VIRGINIA ELECTRIC AND POWER COMPANY
RICHMOND, VIRGINIA 23261

February 4, 1977

This is in response to your letter of January 19, 1977 wherein you requested information regarding the Surry Unit No. 1 steam generators. The response to your specific requests are provided in the attachment to this letter.

NRG REQUEST FOR ADDITIONAL INFORMATION

Figure 1. Finite Element Model.

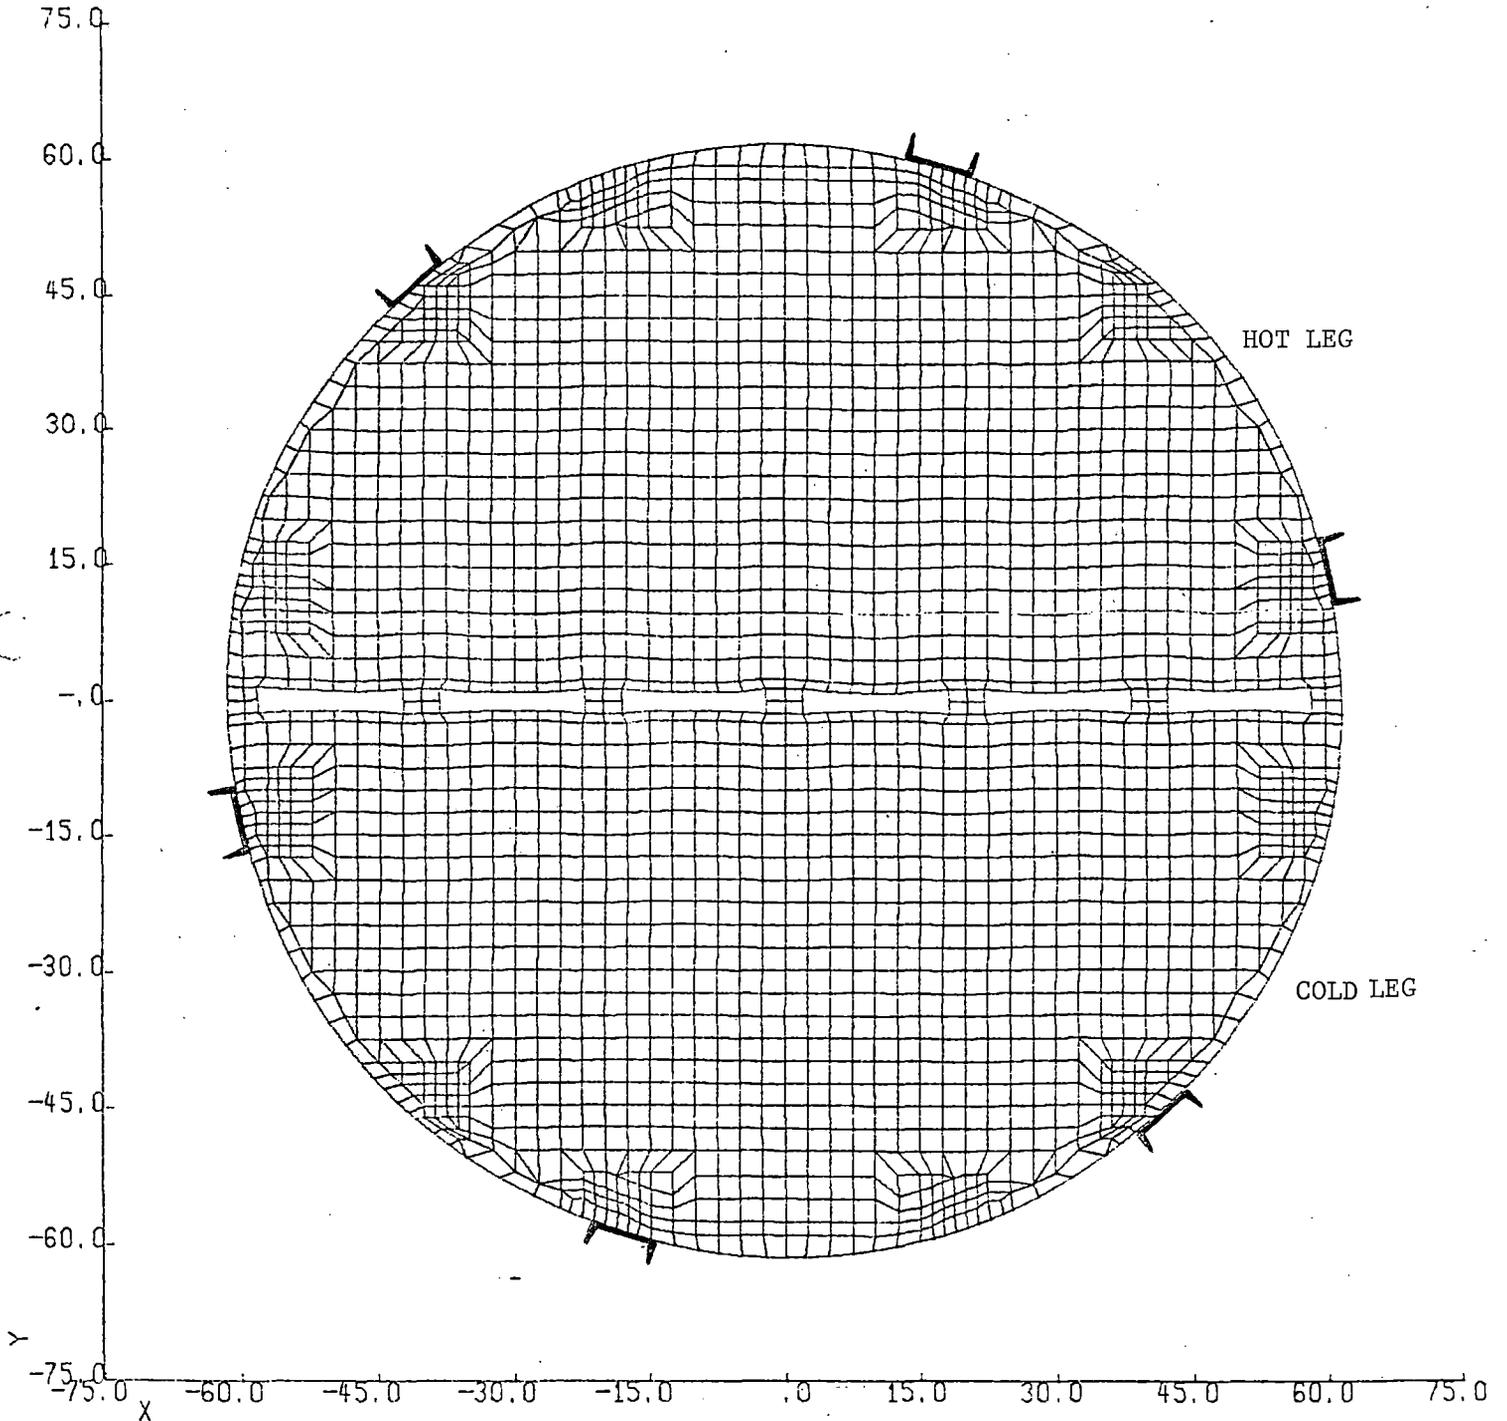
Question 1

For a plate expansion of .014 in/in (hot leg) and .010 in/in (cold leg) applied to the updated plate model (Figure 1), the average flow slot closure which results is .675 inches

Figure 1

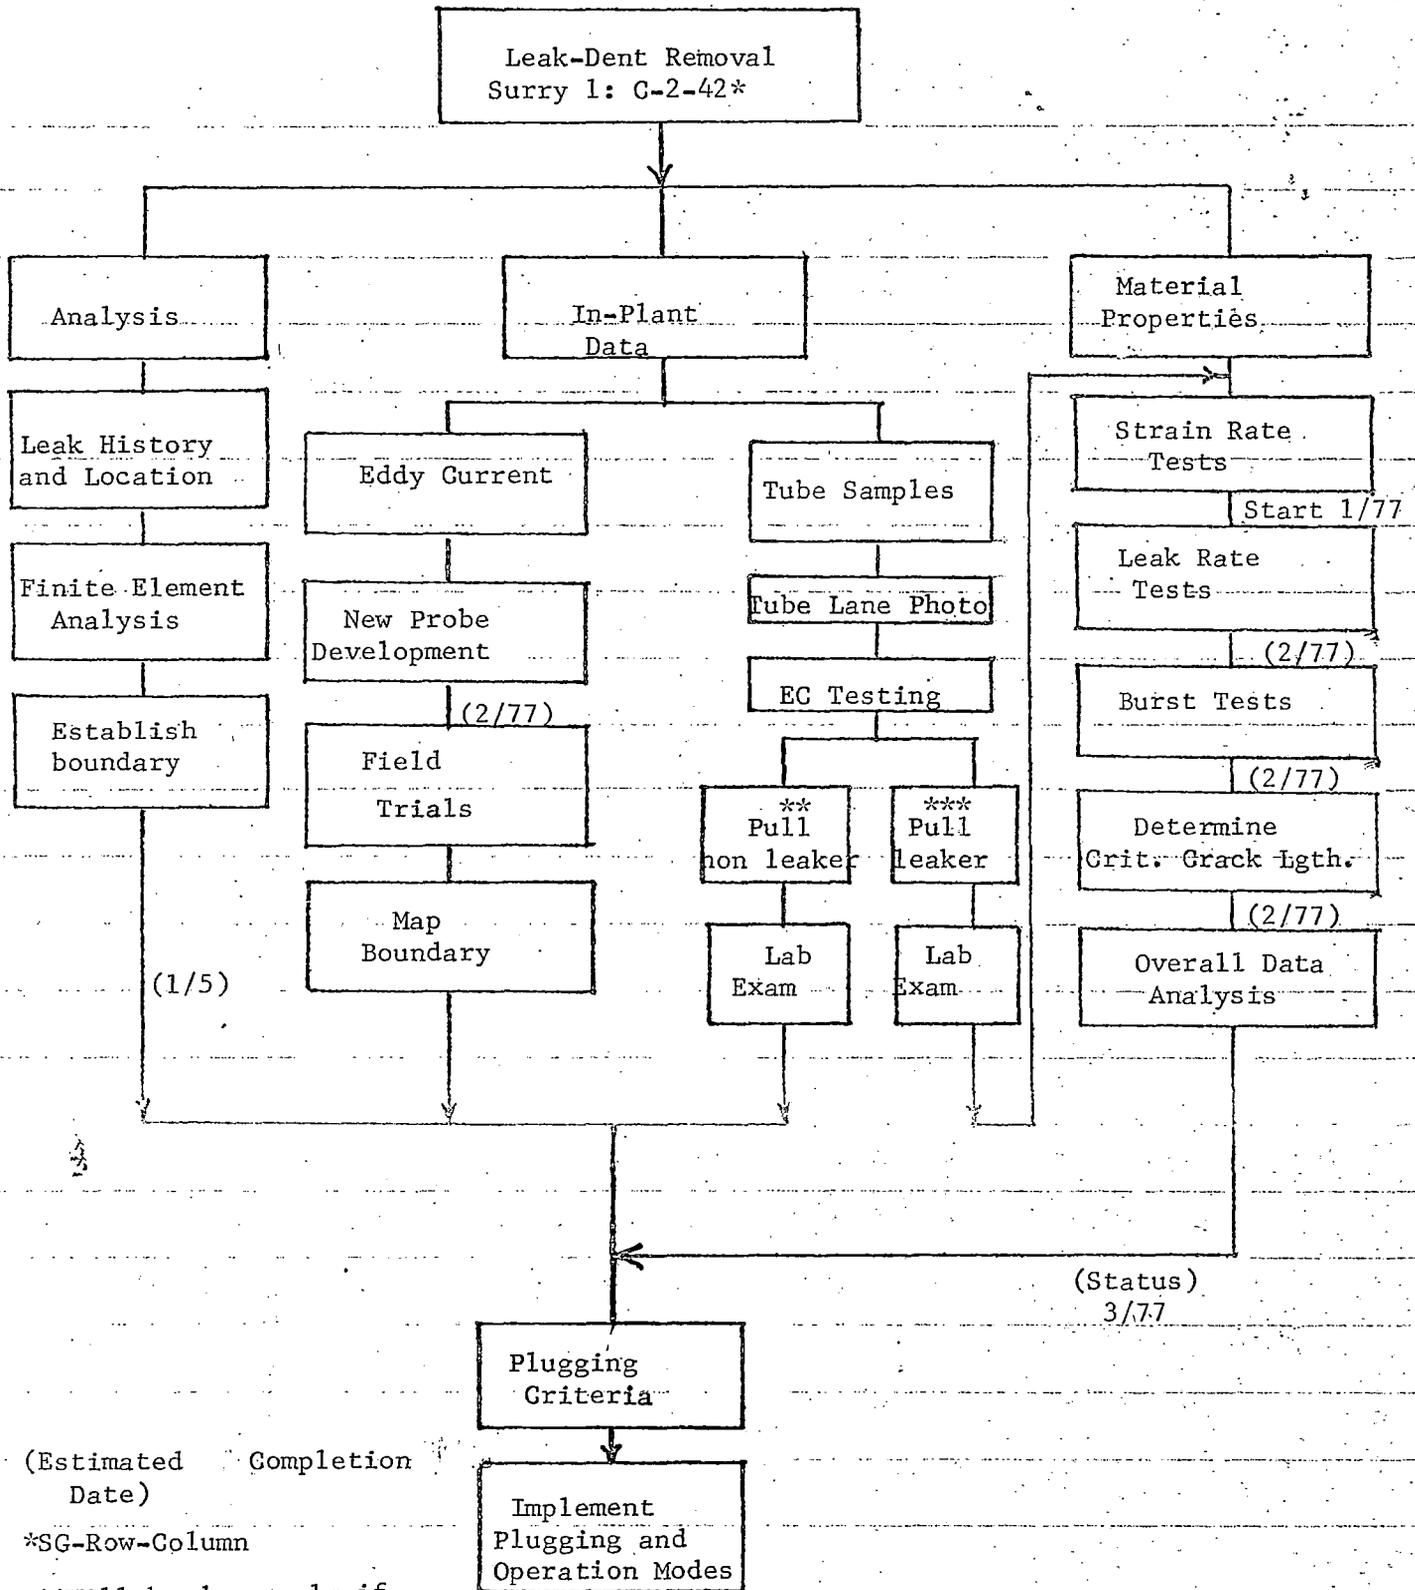
Question 2

A. A continuing effort is underway to investigate the particulars of the cause of leakage at certain dented regions of the steam generator tubes. This effort is given in the diagram of scope shown in Figure 1 and consists of three principal tasks: Analysis, In-Plant Data, and Material Properties. The estimated completion dates associated with the major activities are also shown on the diagram.

2. In-Plant Data: The results of examination of the one leaking-dent tube sample, Surry 1, steam generator G, R2G42, indicated that additional in-plant data should be obtained by both NDE methods and additional tube sample removals. Shown in Figure 1 are the planned efforts to address these issues.

Eddy current techniques for detection of flaws in dented regions have been pursued for some time without much success. The effort is continuing, however, with the development of new probe configurations which are designed to null out tube deformations at dented regions and allow the presence of a flaw to be discernable. Once the newly developed probes are manufactured for field use, trials at Surry 1 or 2 will be scheduled. Because of the uncertainty of this development work, a target date of the end of February, 1977 is shown in Figure 1.

Additional tube sample removals are shown in Figure 1. One sample of a leaking dent will be pulled when a suitable candidate is identified and available. This tube will serve the purpose of confirming the mode of failure determined for the G-2-42 tube. Another tube, which has not leaked, will be identified to confirm the boundary for those tubes subject to leakage.
